# HISTORIC AND DESIGN REVIEW COMMISSION

**HDRC CASE NO:** 2017-397  
**ADDRESS:** 415 WILLOW  
**LEGAL DESCRIPTION:** NCB 1653 BLK A LOT N 55 FT OF 17 & 18  
**ZONING:** R-5, H  
**CITY COUNCIL DIST.:** 2  
**DISTRICT:** Dignowity Hill Historic District  
**APPLICANT:** Eduardo Villalon  
**OWNER:** Eduardo Villalon  
**TYPE OF WORK:** Construction of a two story, single family residential structure  
**APPLICATION RECEIVED:** June 29, 2018  
**60-DAY REVIEW:** August 28, 2018  
**REQUEST:**

The applicant is requesting a Certificate of Appropriateness for approval to construct a two story, single family residential structure on the vacant lot at 415 Willow in the Dignowity Hill Historic District.

415 WILLOW STREET  
SITE PLAN  
SCALE: ----- 1/8" = 1' - 0"

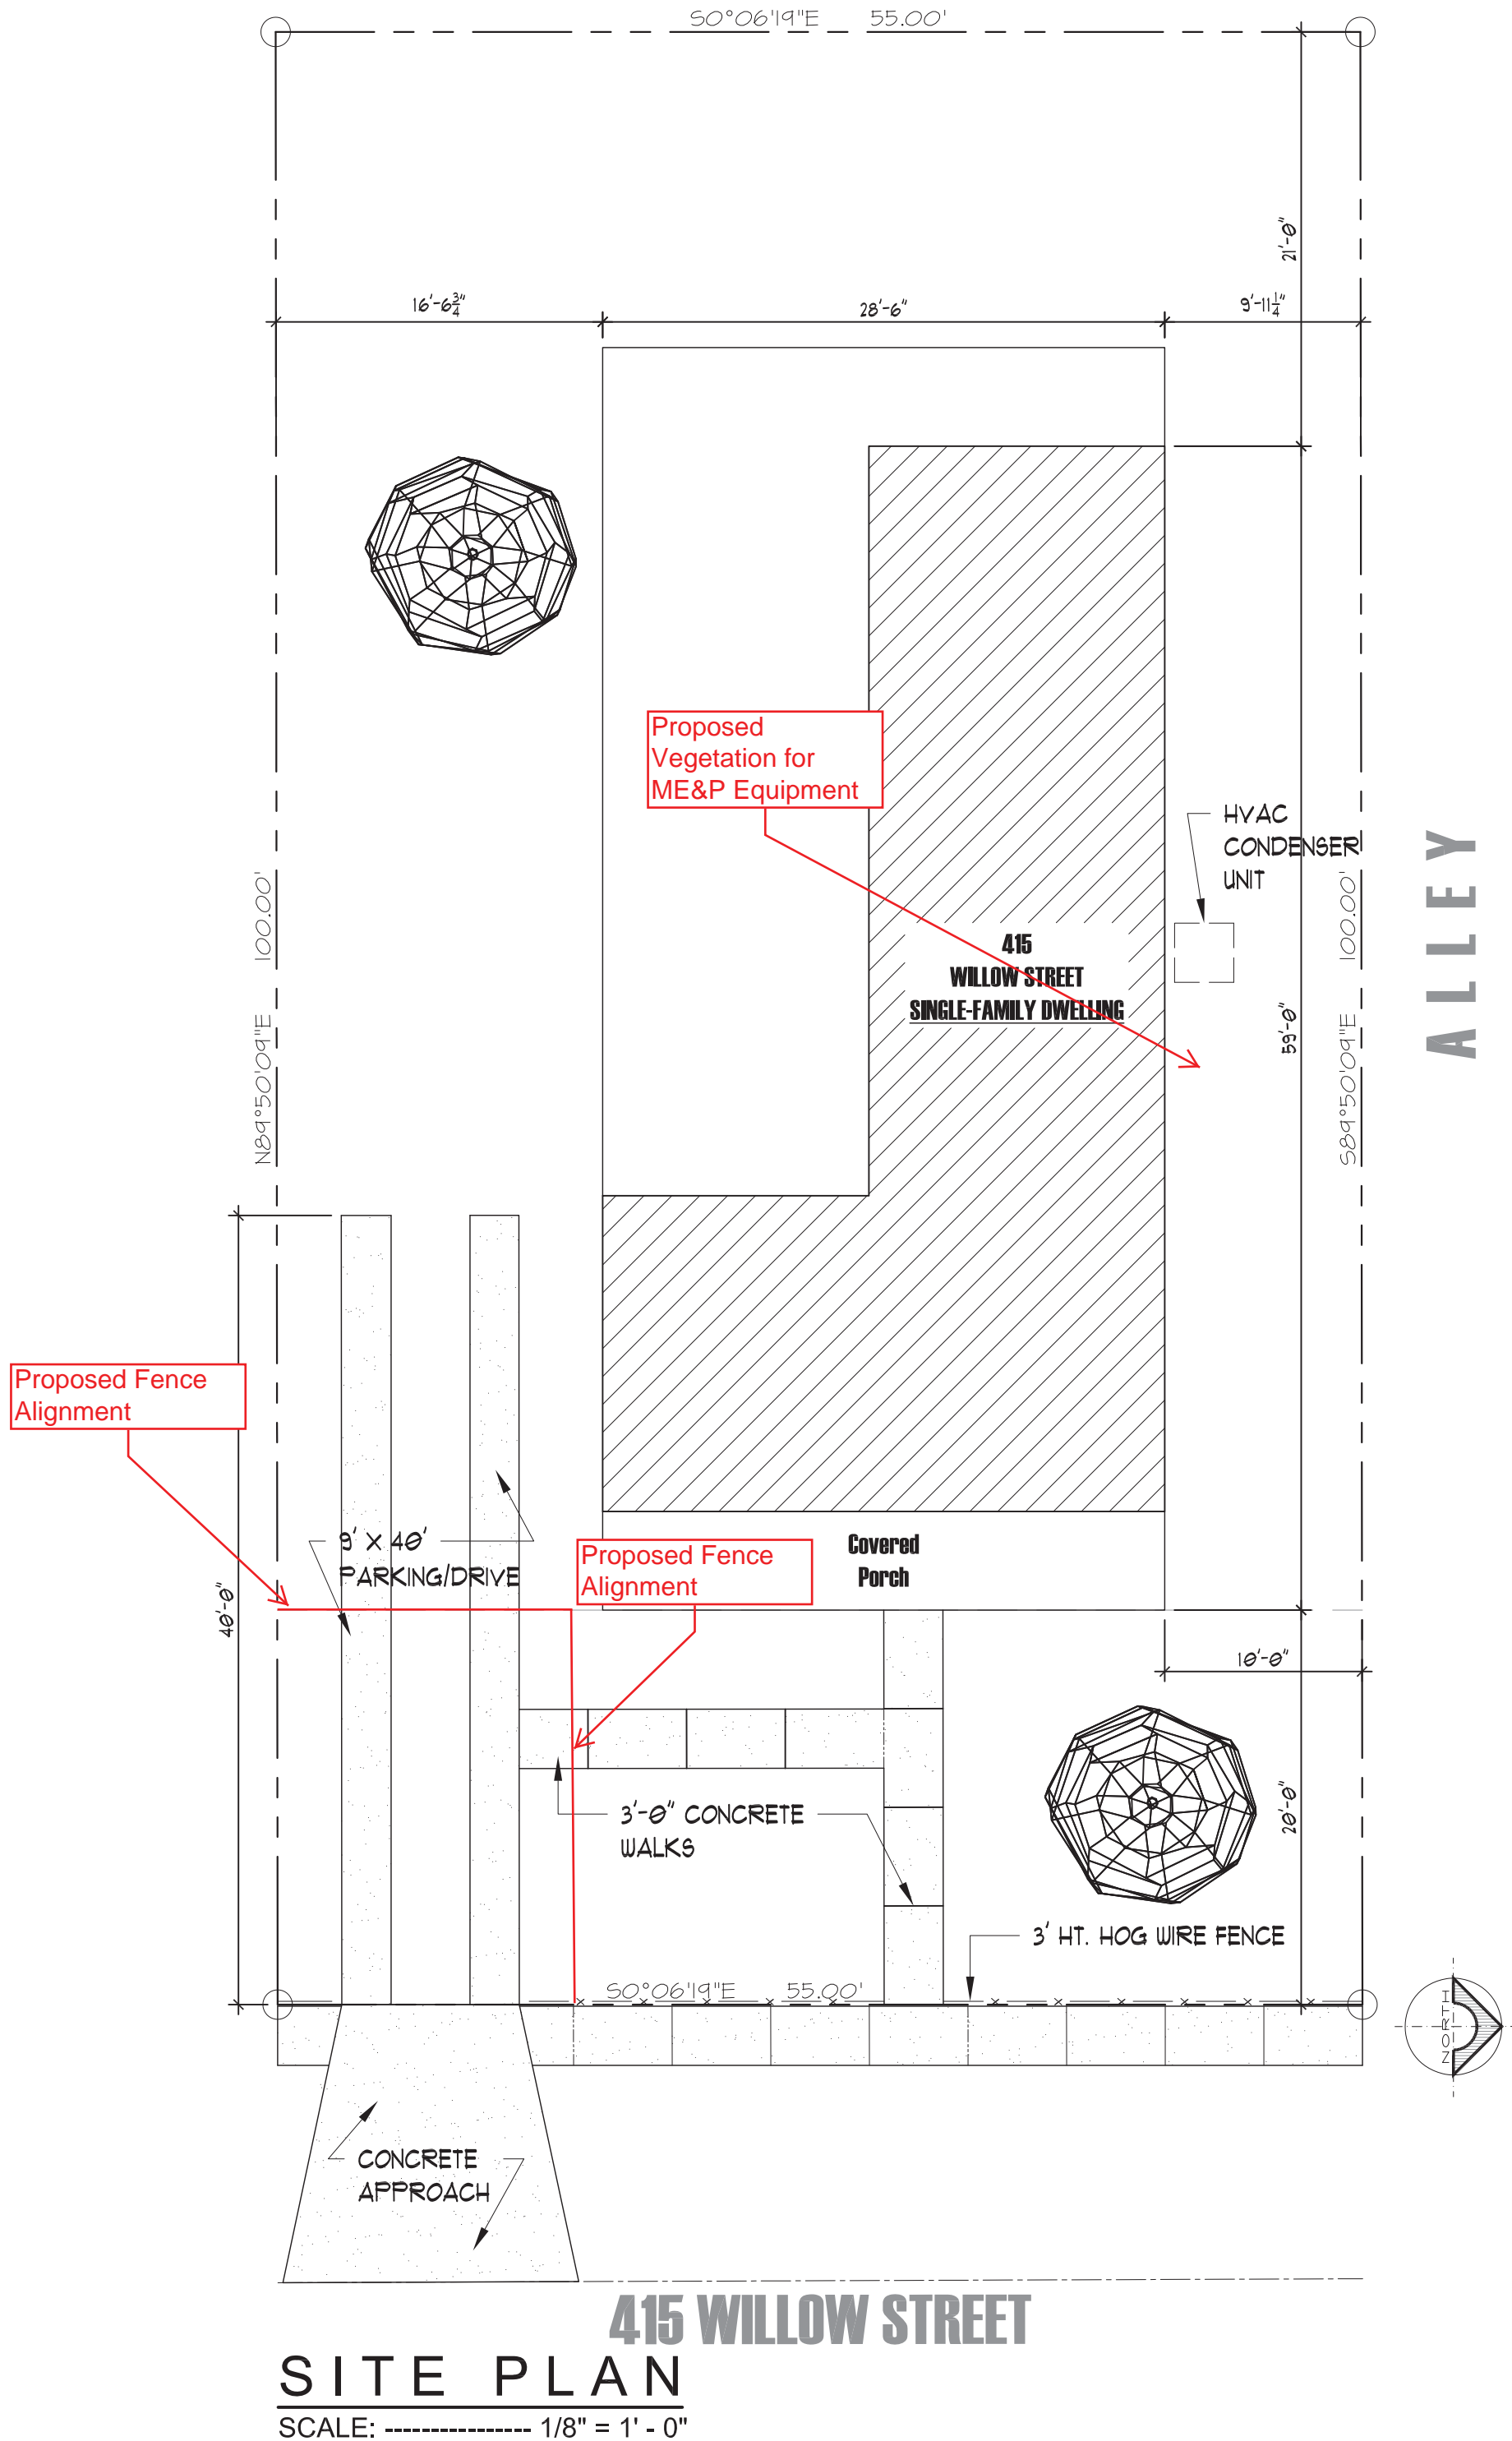
- i. That the applicant provide information noting the setbacks of adjacent historic structures and that the proposed new construction matches. **The applicant has proposed a setback of twenty (20) feet from the existing sidewalk to the front face of the porch.**

- vi. That the applicant provide a detailed drawing of the proposed porch columns and that the columns not exceed six inches in width.
  - vii. That the proposed driveway extend along the side of the proposed new construction. **The applicant has updated the proposed site plan to include this.**

- n. DRIVEWAY – The applicant has proposed a driveway that is to extend along the side of the proposed new construction. The applicant has noted a profile of concrete ribbon strips and an overall width of nine (9) feet. The proposed driveway is appropriate and consistent with the Guidelines.

- o. SIDEWALK – The applicant has proposed a front yard sidewalk to lead from the sidewalk at the public right of way to the front porch to be centered on the front door and to lead from the front walk to the driveway. The proposed sidewalk is to be three (3) feet in width. This is appropriate and consistent with the Guidelines.

- q. FENCING – The applicant has noted per the site plan that a hog wire fence to be three (3) feet in height is to be installed in the front yard. Staff finds the proposed height of the fence to be appropriate; however, staff finds that the propose driveway gate should be located at or behind the front façade of the house rather than at the sidewalk as currently proposed. The applicant is to provide a detailed fence drawing.

- viii. That all mechanical equipment be screened from view at the public right of way.
- ix. That the proposed fence feature a driveway gate that is located at or behind the front façade of the proposed new construction rather than at the sidewalk as currently proposed.
